BID ADDENDUM #2

Bid # RFB-2022-15

SUNY SCCC WELCOME CENTER

C2 DESIGN PROJECT #2006

SHEET: G100

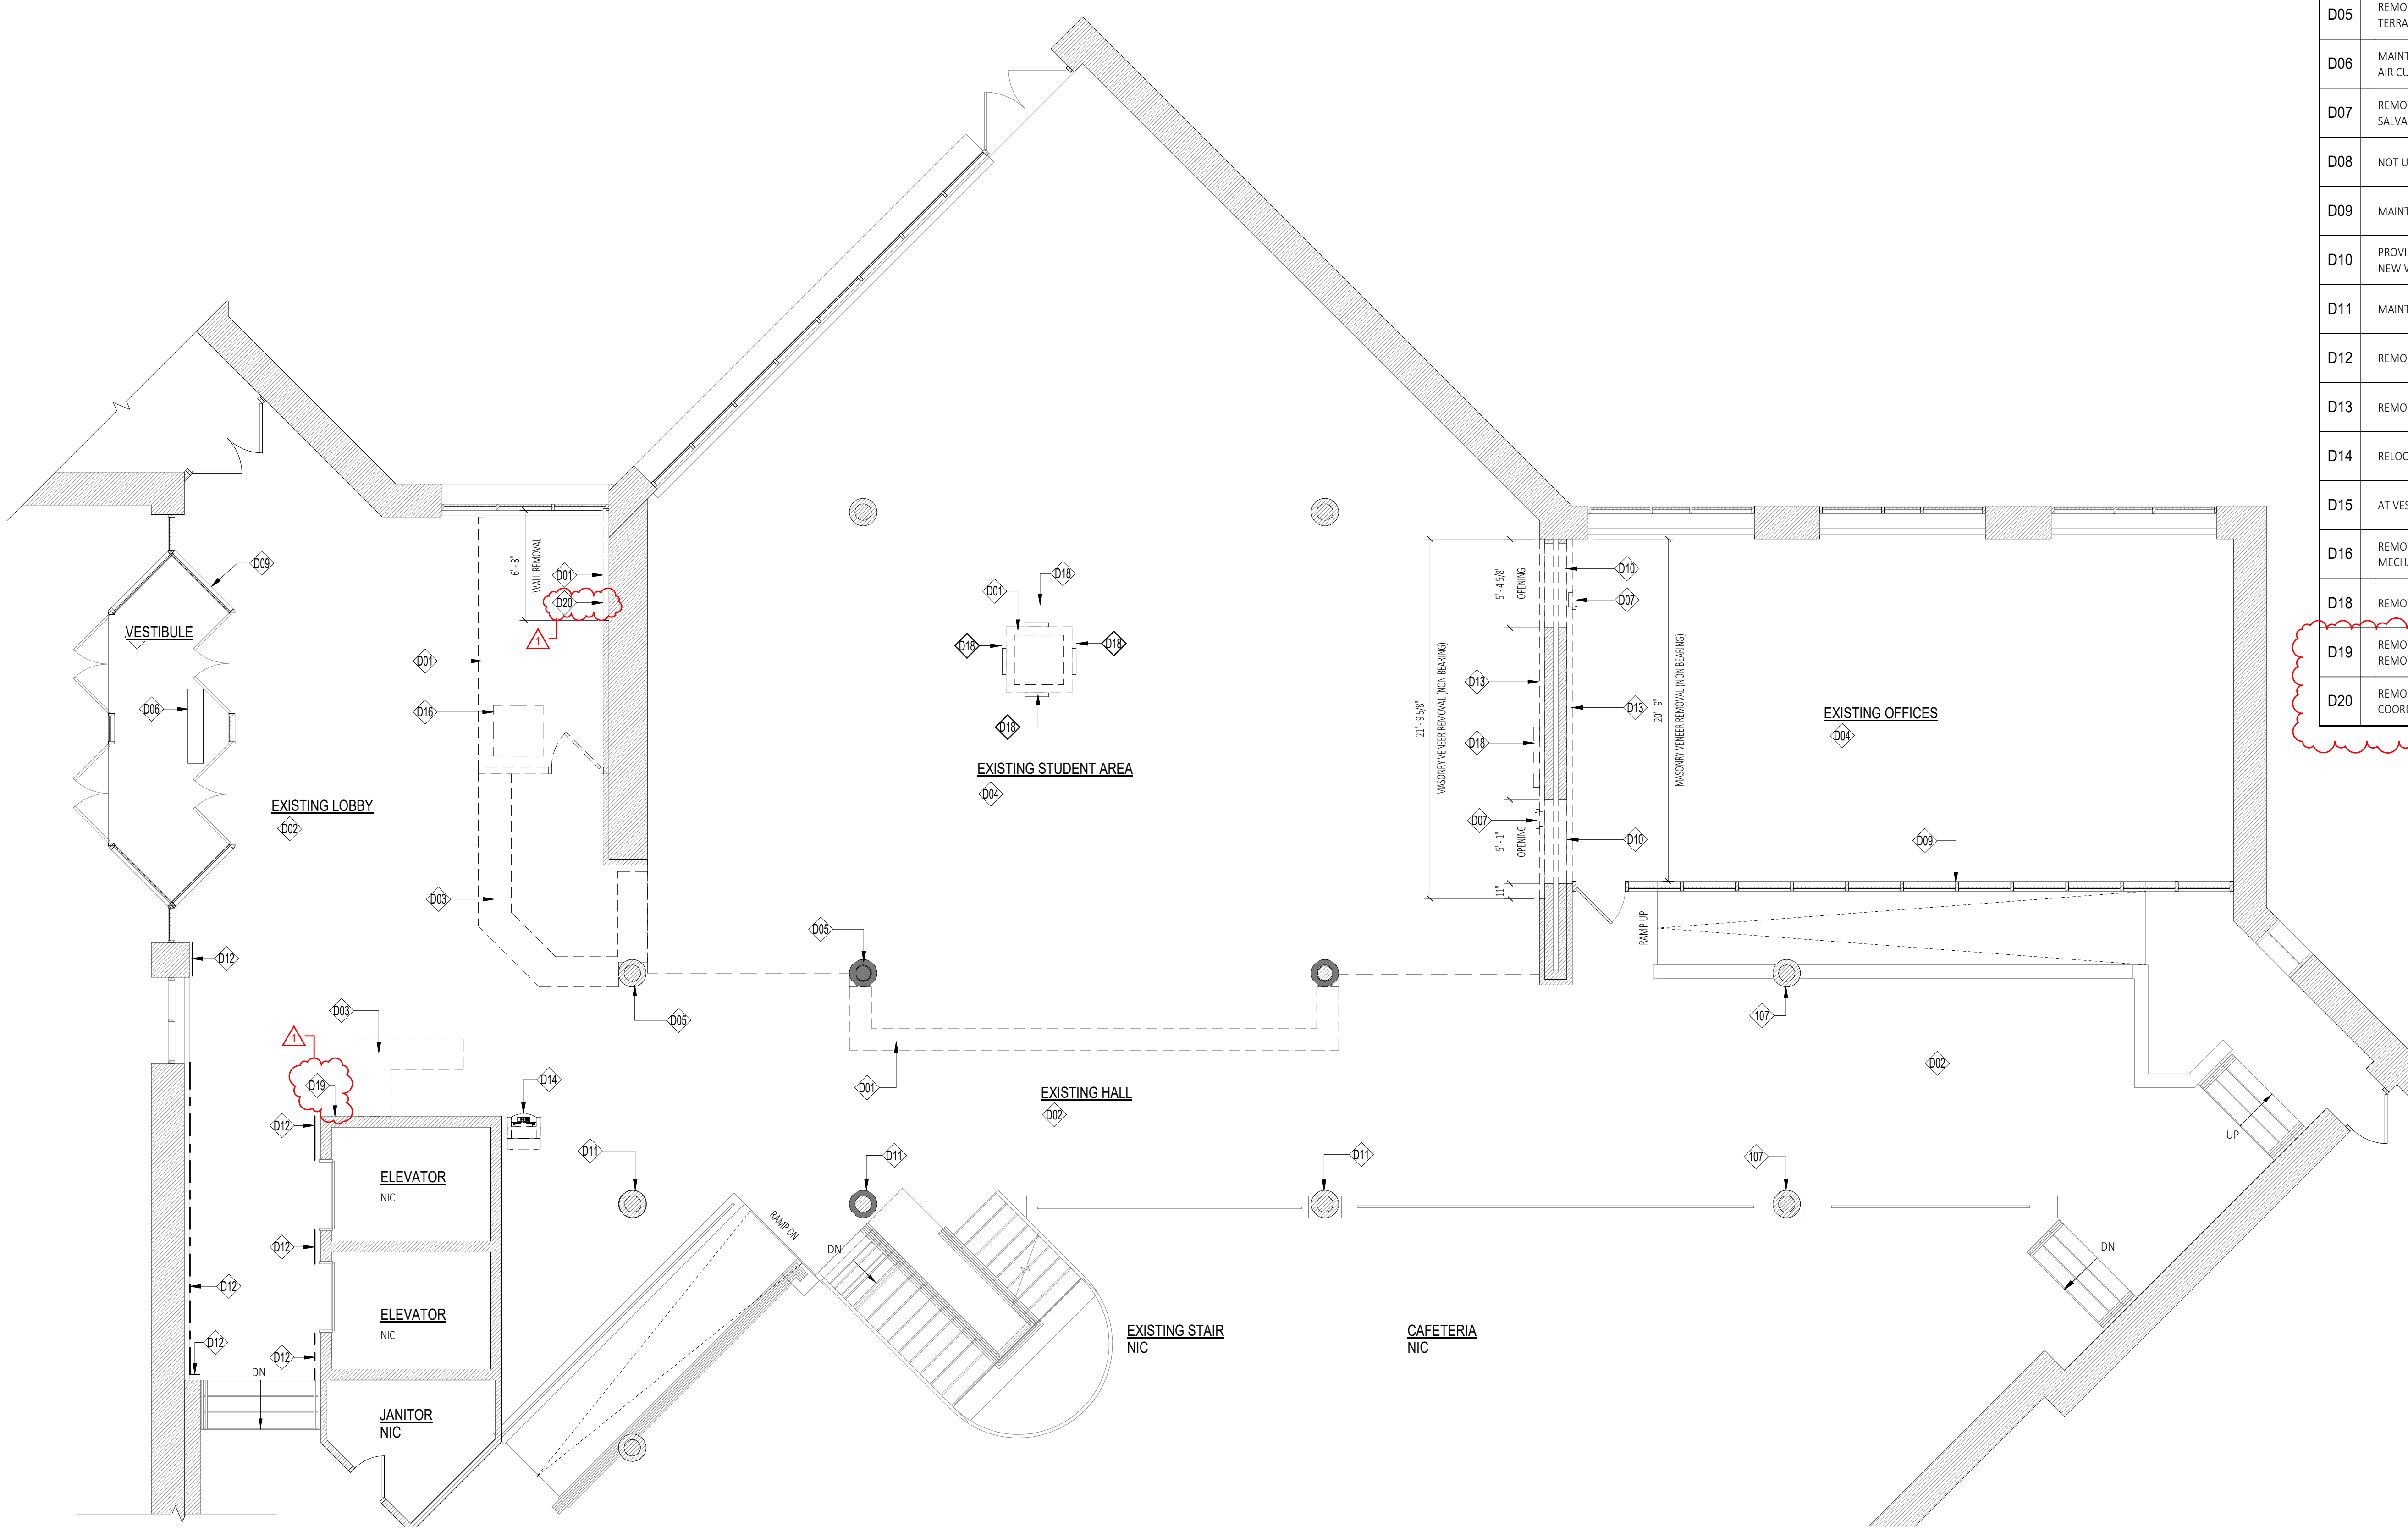
Drawing G100/Cover Sheet:

- Architectural Drawing list:
 - Revisions as noted.

1 Partial First Floor Demolition Plan
 D100 SCALE: 3/16" = 1'-0"

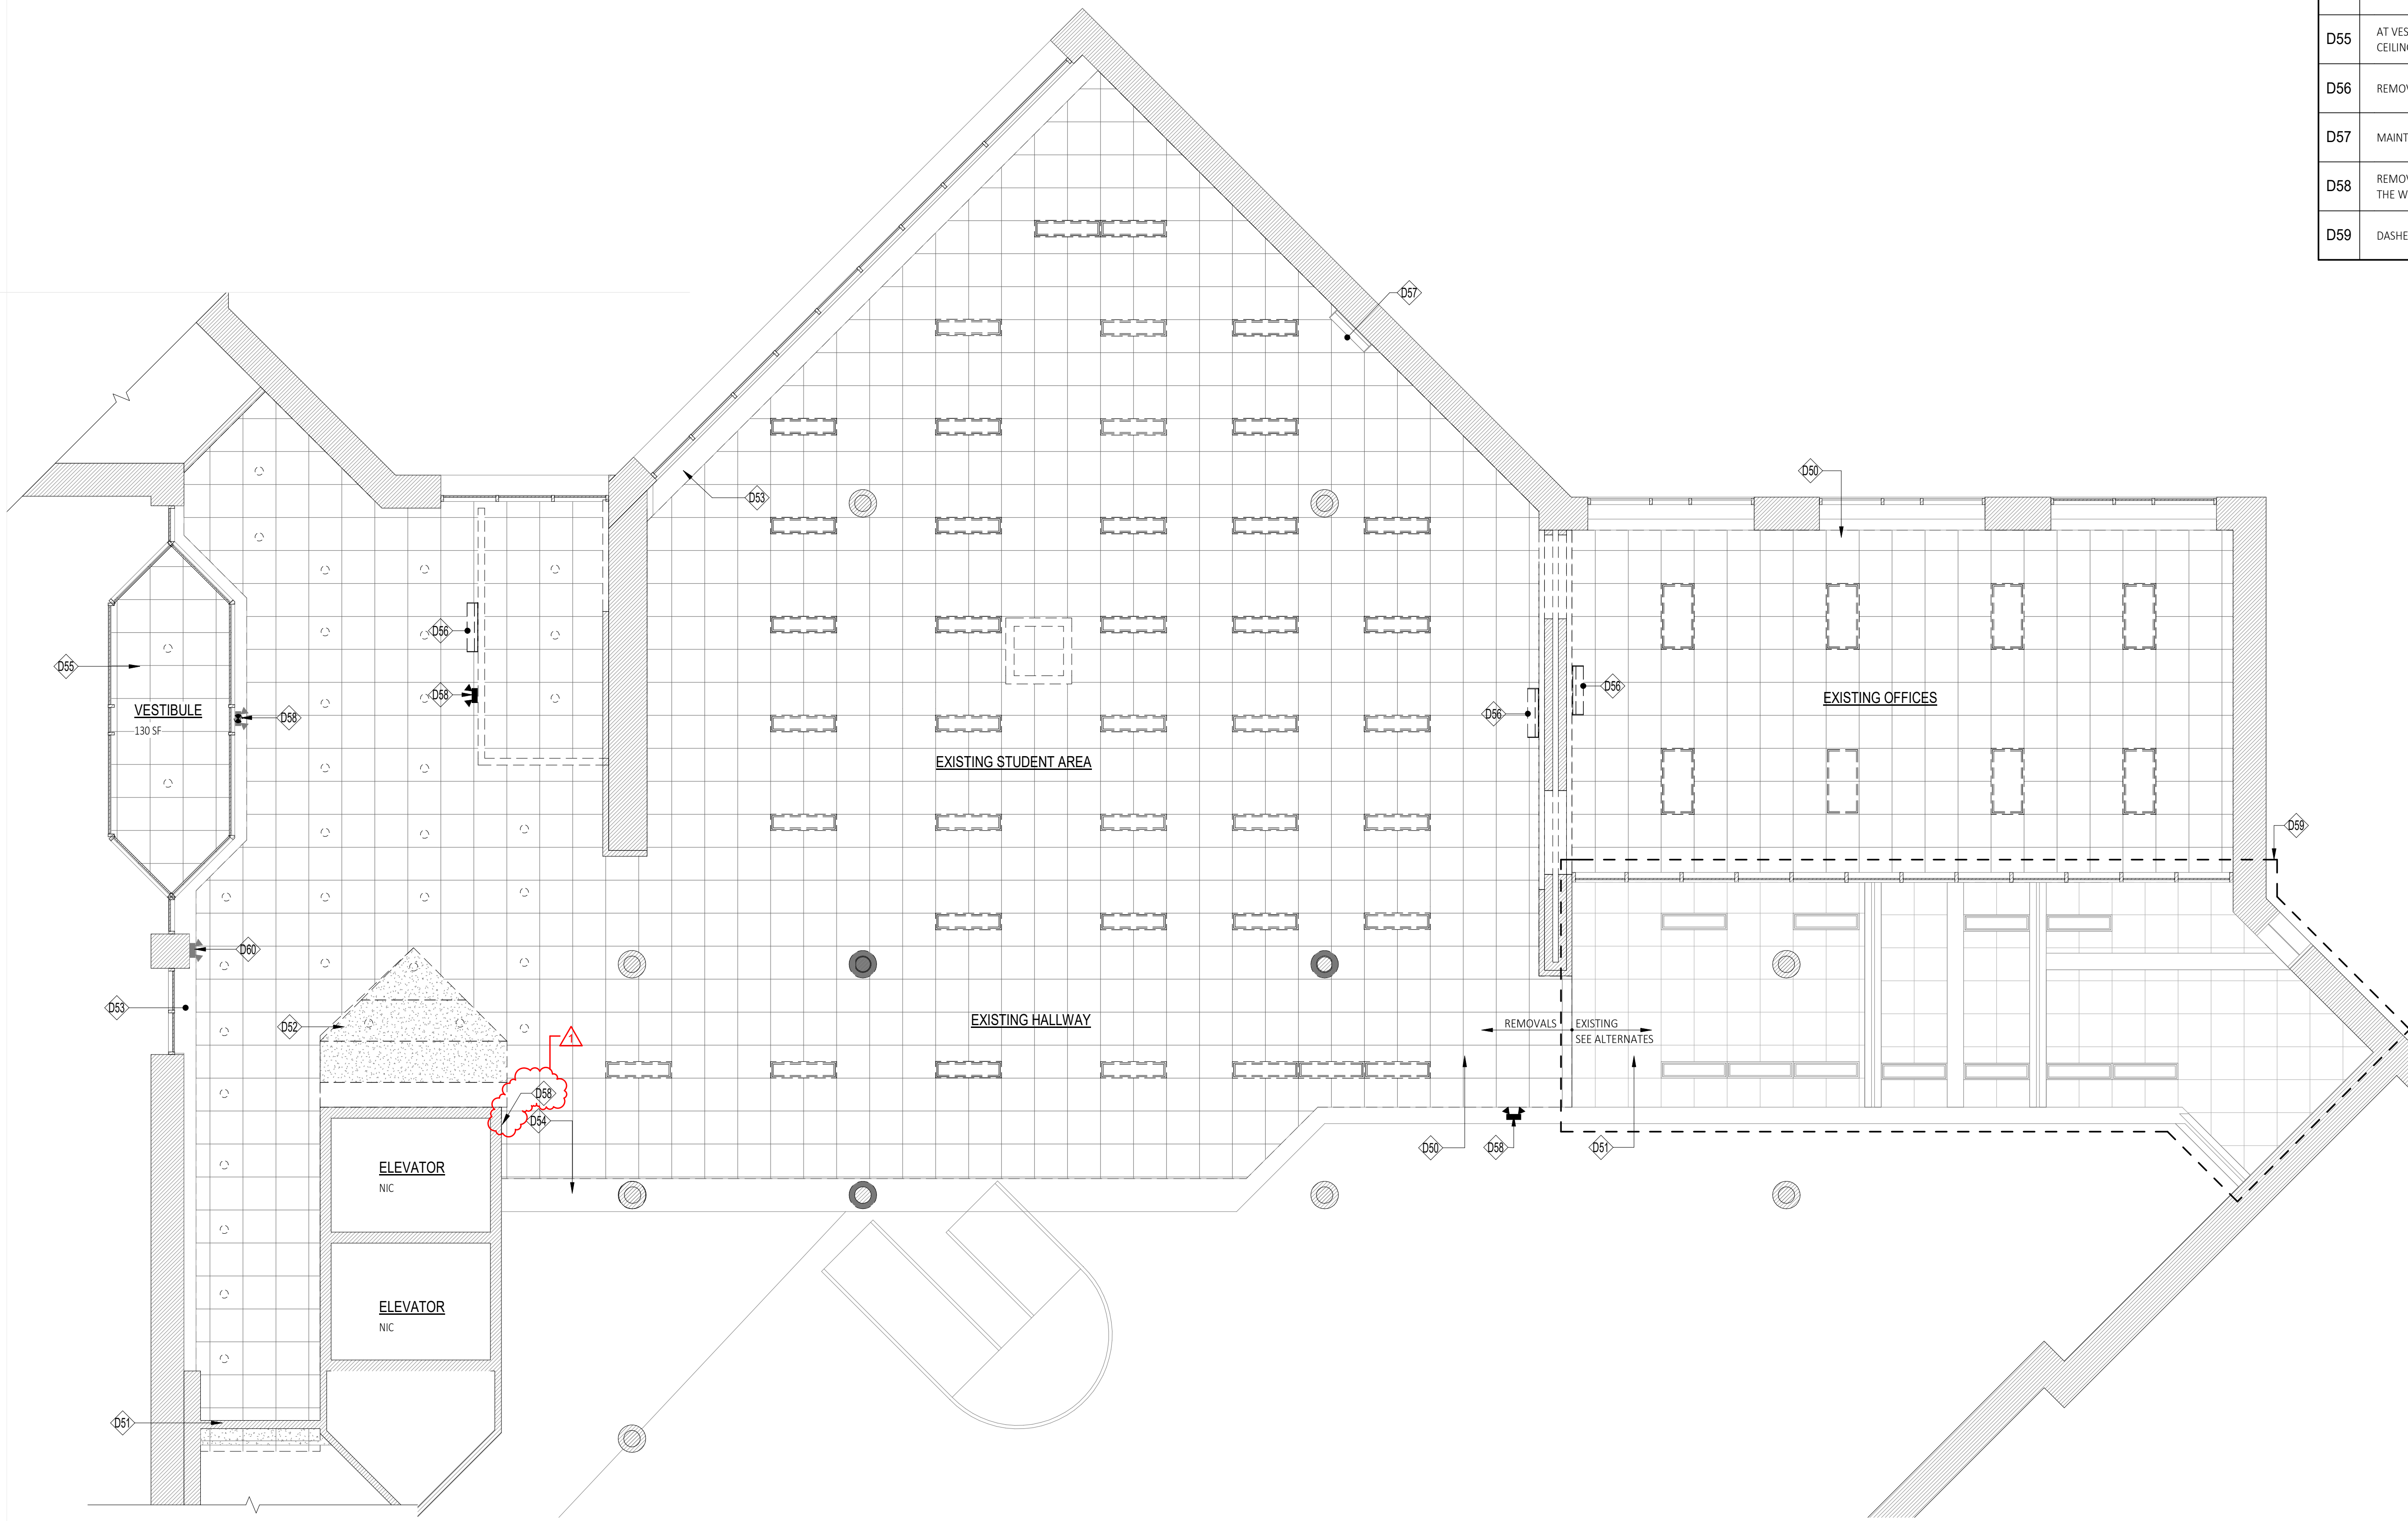
Drawing D100/Demolition Plan:

- Detail 1, Partial First Floor Demolition Plan:
 - Revisions as noted.
- Demolition Floor Plan Legend:
 - Revisions to note D19 & D20.

1
A100 Partial First Floor Plan
SCALE: 3/16" = 1'-0"

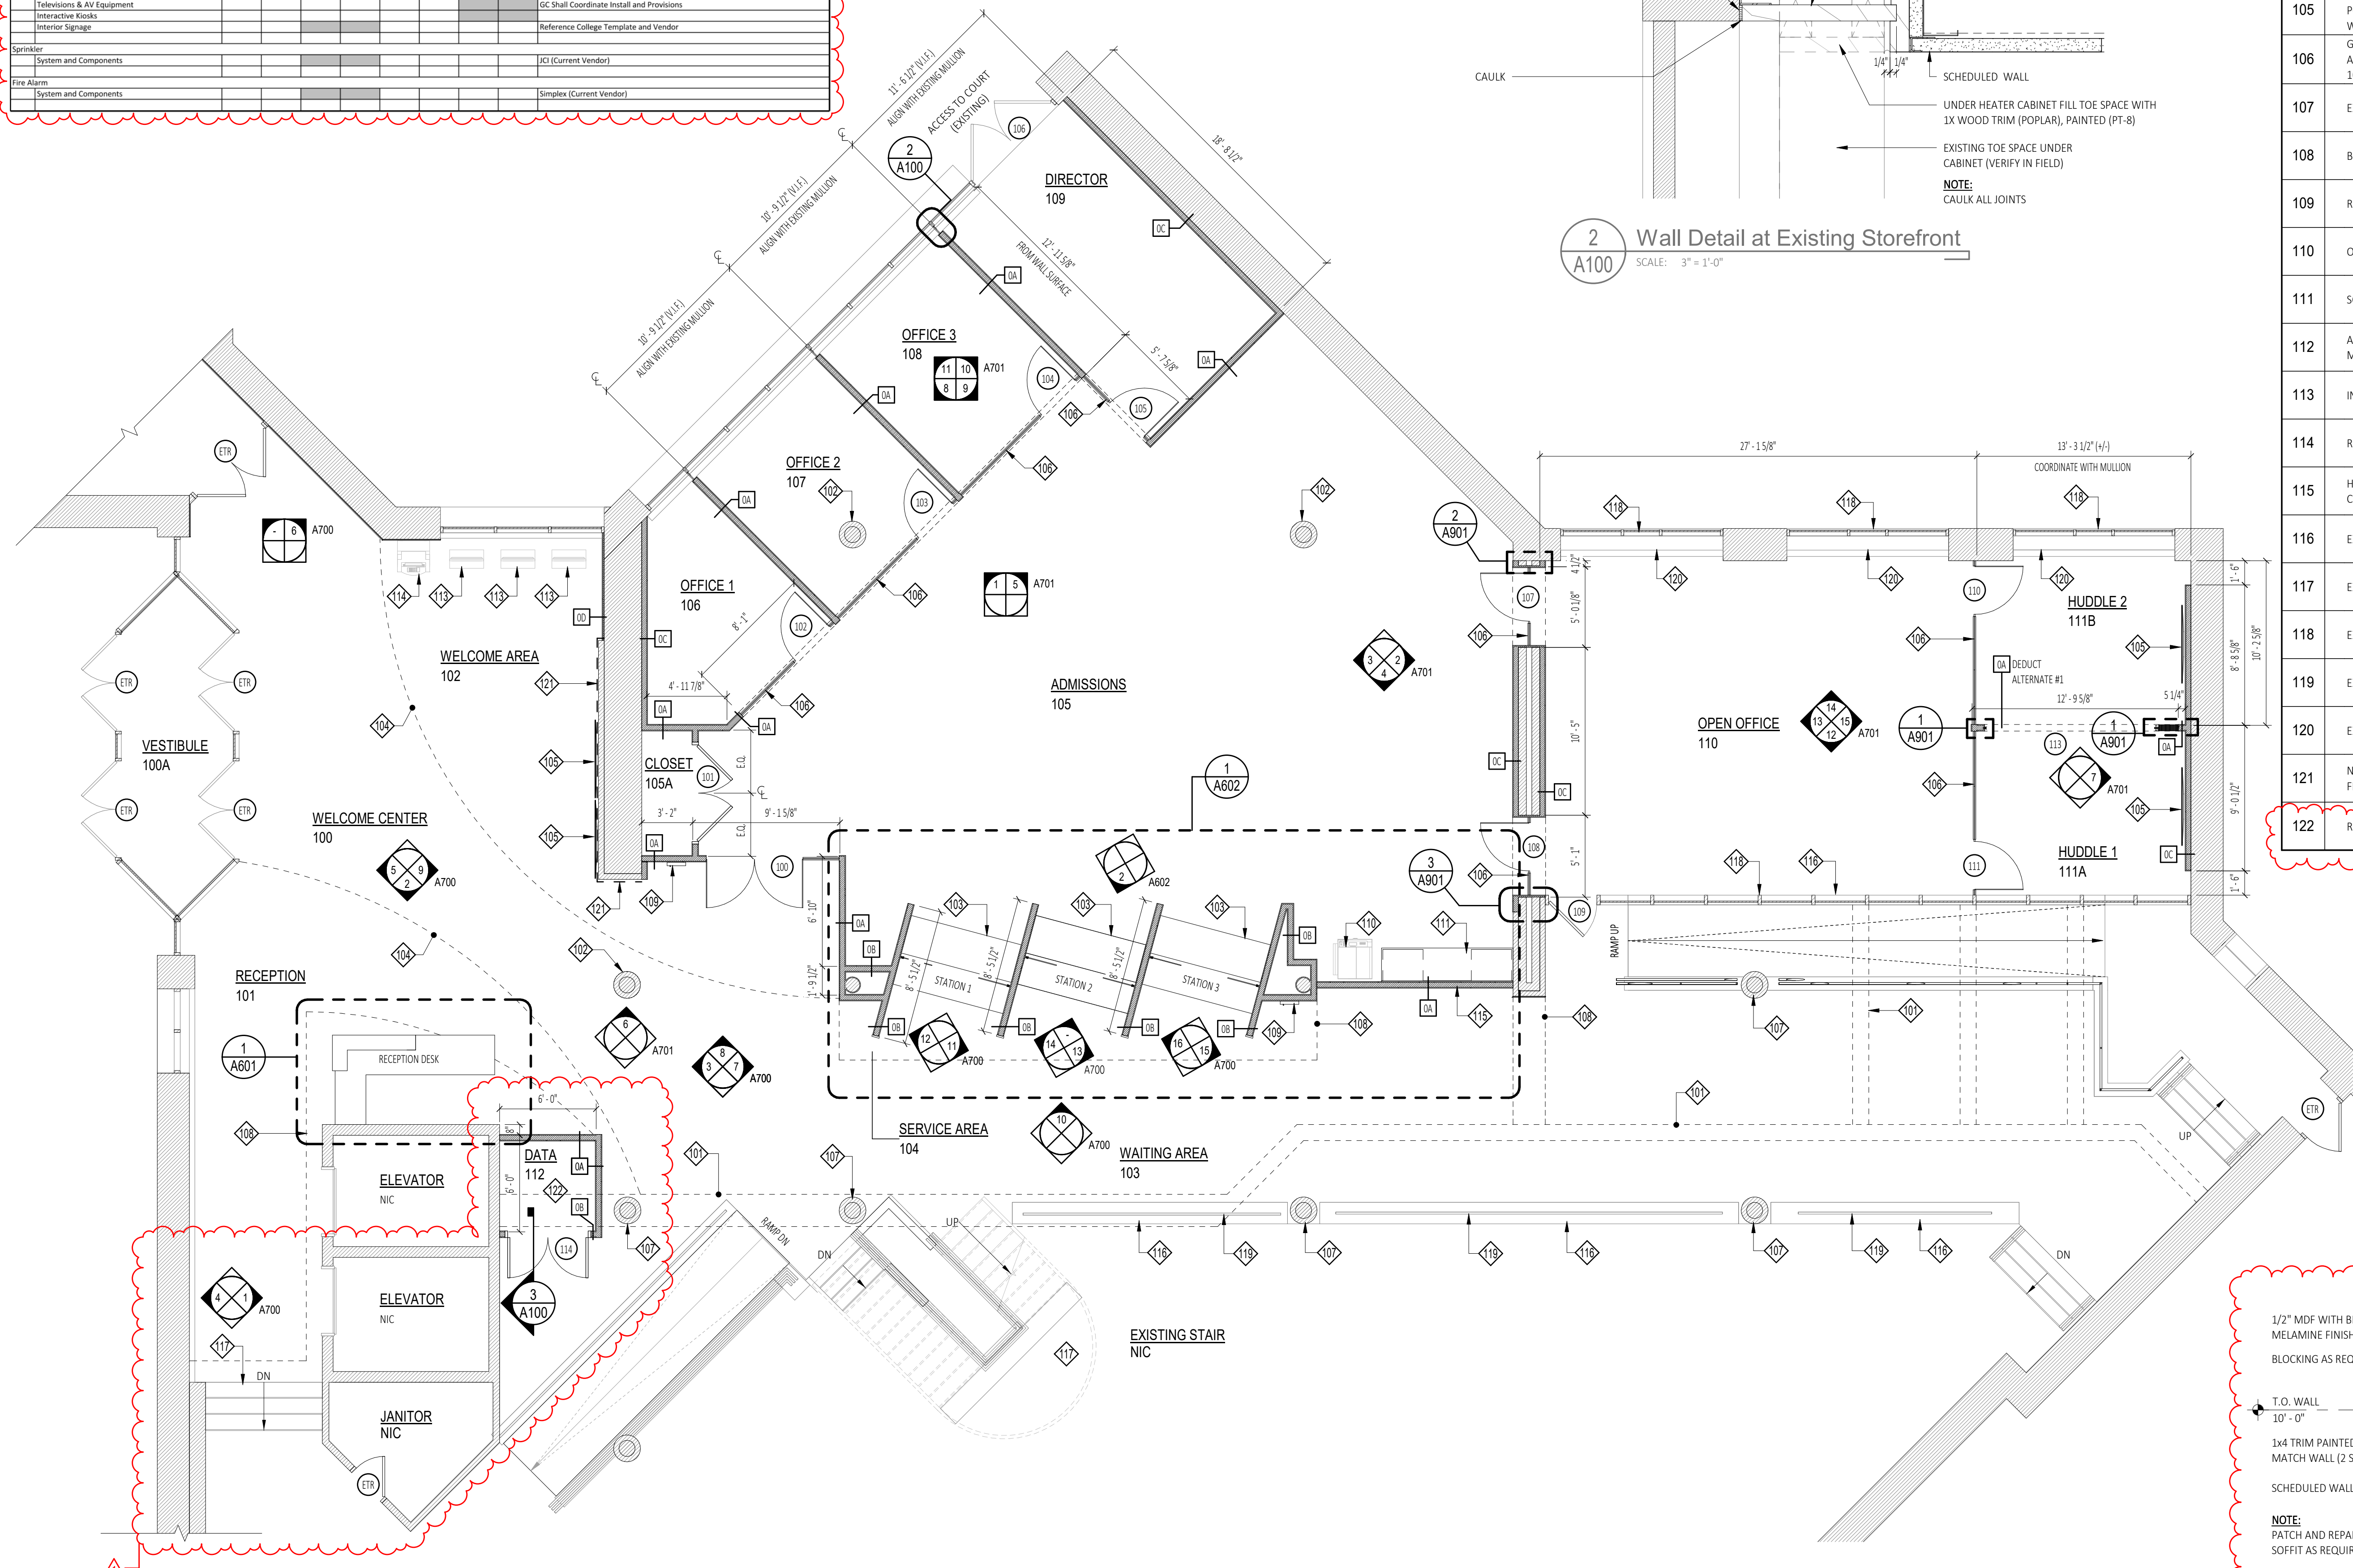
Drawing A100/Detail 1, Partial First Floor Plan:

- Data 112:
 - New Data room with new door 114 and details as noted.
